ON-SITE SEWAGE DISPOSAL SYSTEM HOWARD COUNTY HEALTH DEPARTMENT BUREAU OF ENVIRONMENTAL HEALTH

SUBDIVISION: Cattail Creek Country Club LOT NUMBER: 11

ADDRESS: 3662 Broadleaf Court PROPERTY OWNER: Trinity Quality Homes

PLAN BY CFS 1:50

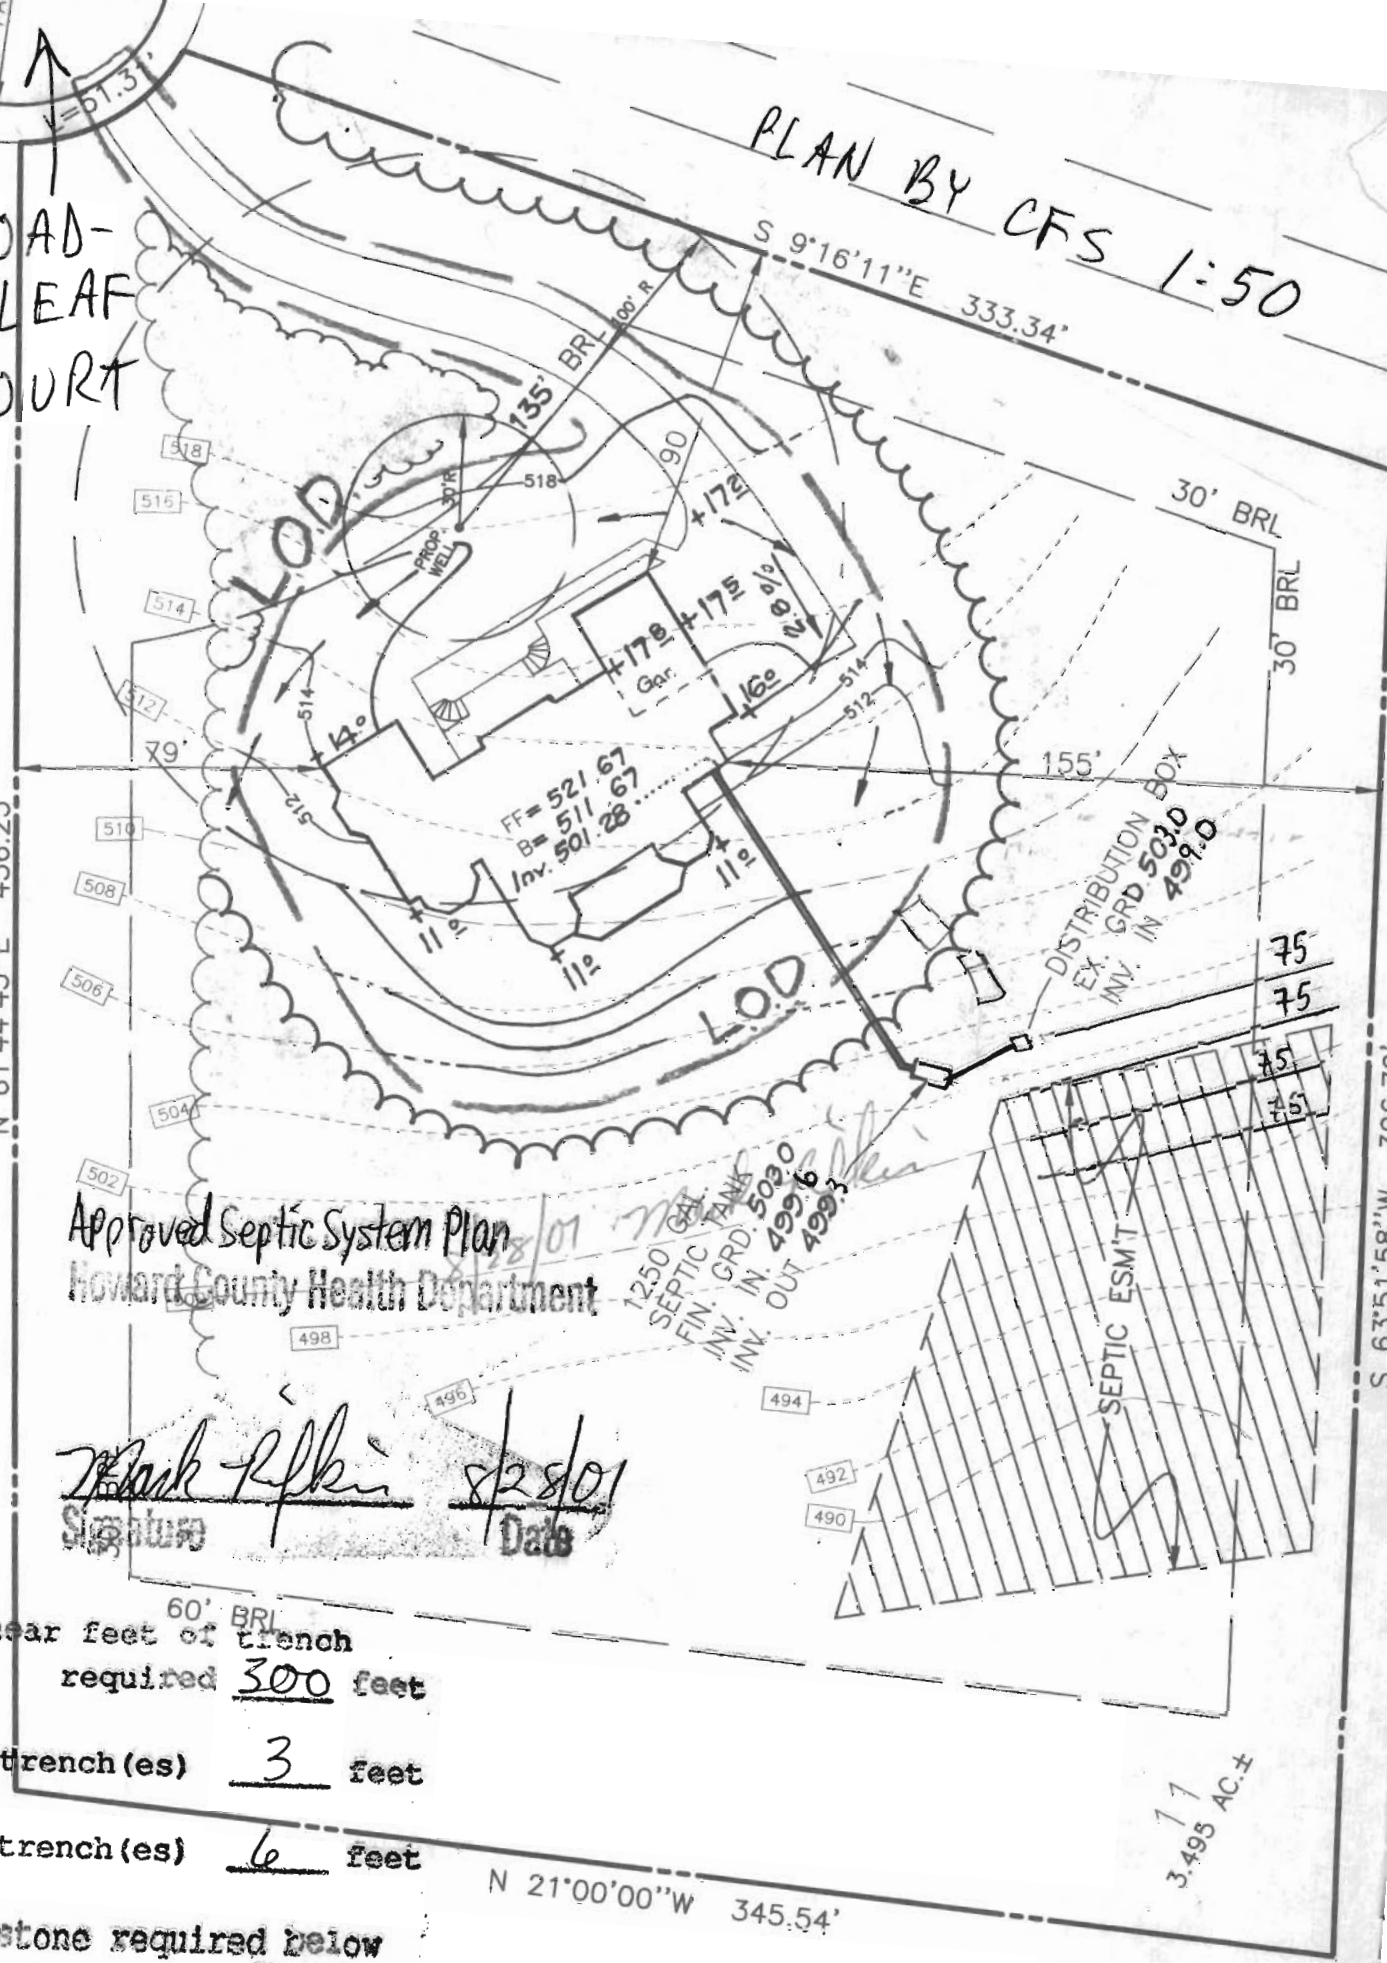
PRE-CONSTRUCTION INSPECTION: 7/3/02 Layout per B.P. Changed
input to 3, bottom @ 5' (SC)

9/2/03 ± T/C w/ KENNY MAYNE: REAR BAFFLE RE-INSTALLED CLOSER TO S.T. WALL, OUTLET PIPE FALL CORRECTED AFTER OWNER COMPLAINTS OF ODOR (MR)

9/9/03 OWNER COMPLAINT INSP: S.T. 6" B.G., S.T. LID SECTION HAS 1/2" GAP (MR)
OWNER WANTS JOB REPAIRED (MR) 10/16/03 T/C w/ OWNER: JOB COMPLETE 18" COVER PRESENT
